| | 316 Stainless | End Post, Stainless Steel, 2.00 Inch Square x 0.12 Inch Wall, 42 High, Brushed Satin Finish, Grade 316, Fascia Mount, Flat Plt | | |
| WEIGHT: | DRAWN BY: | | COLLABORATIVE METAL WORKS | |
| | | LG32242DEFM.4 | | |

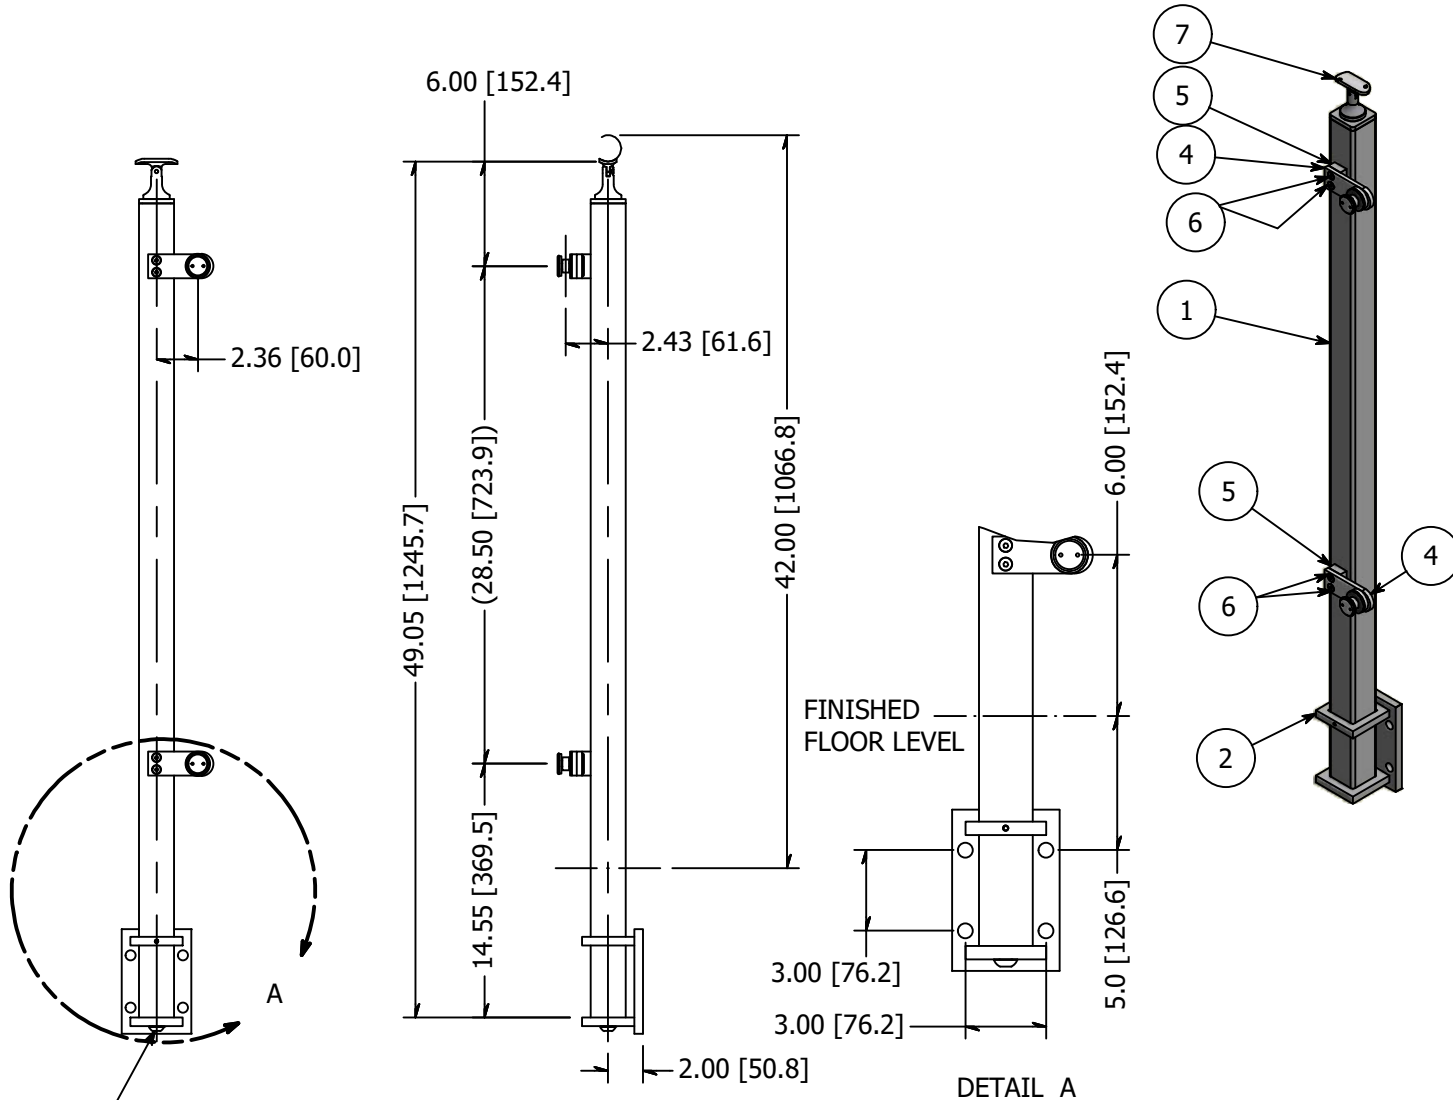
| REVISION HISTORY | | | |
|------------------|--|-----------|----------|
| 2 | Wall Thickness was changed from 0.25 to 0.12 and the corner radii from .375 to .188 on the square post. BAH3N1213-0200 WAS BAH3N3816-0200. | 3/13/2019 | ATM |
